URS Greiner Woodward Clyde

Parcel T9 - 1155 Clay Street, Oakland

Project No. 510996706000

A2.02

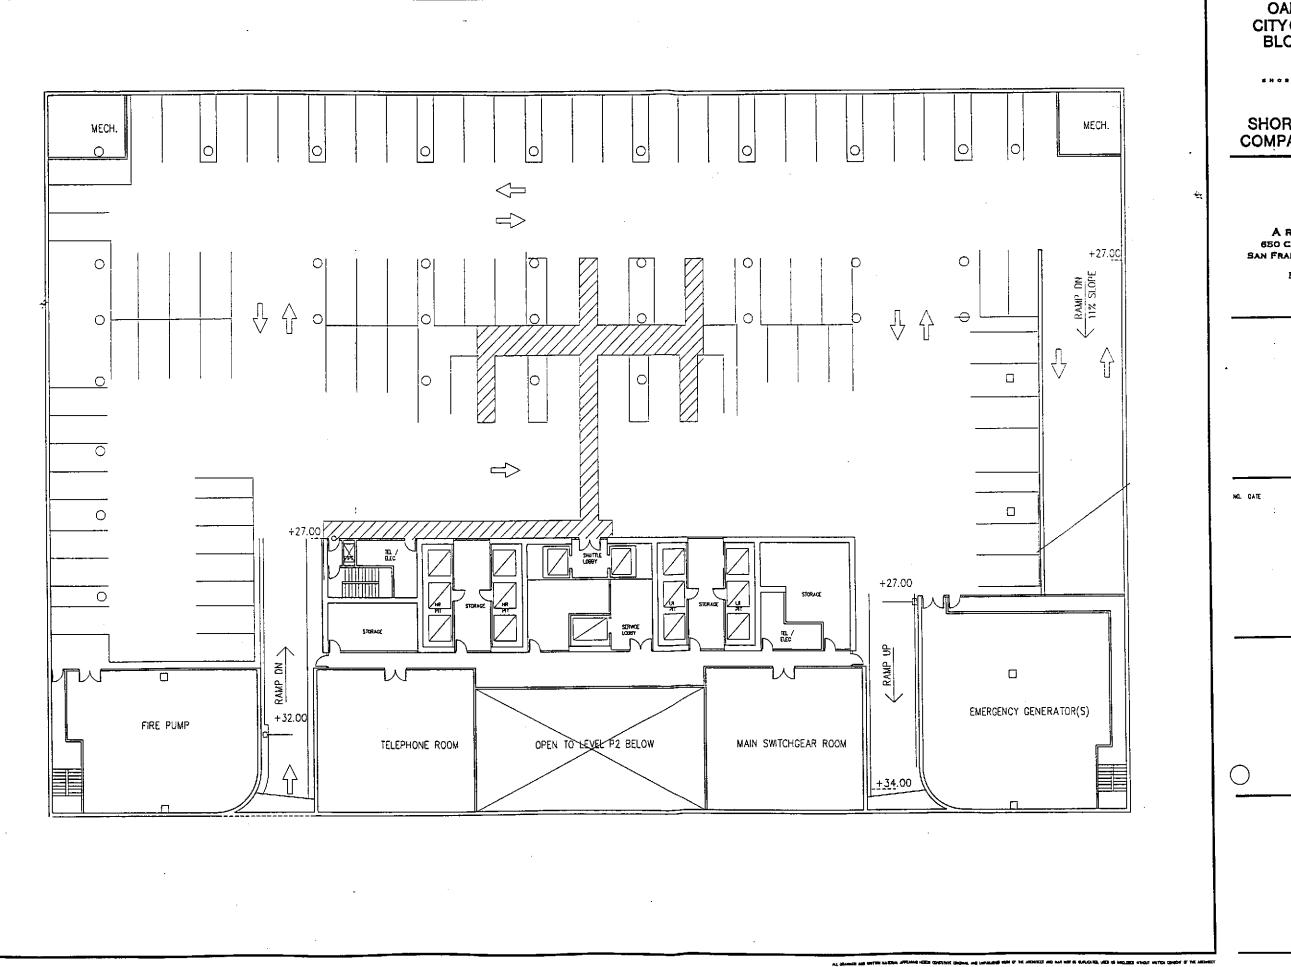
- 1. A site map is enclosed. As you can see, the underground parking structure will cover the entire parcel.
- 2. As discussed by telephone, sampling locations have not been pre-selected since it is more prudent to select sampling locations based on field observations (e.g., PID measurements, odors, staining of soil, etc.) during the excavation. Furthermore, sampling of the walls of the excavation may not be possible since protective shoring may prohibit access to the excavation sidewalls. However, if it is technically feasible, then we would endeavor to collect excavation floor and sidewall samples on the basis of approximately one sample per 5,000 square feet of excavation surface (i.e., one sample approximately every 70 feet). Sidewall samples would be collected just above the water table where there is the potential to represent an off-site migration source, particularly in the southwest corner of the parcel.
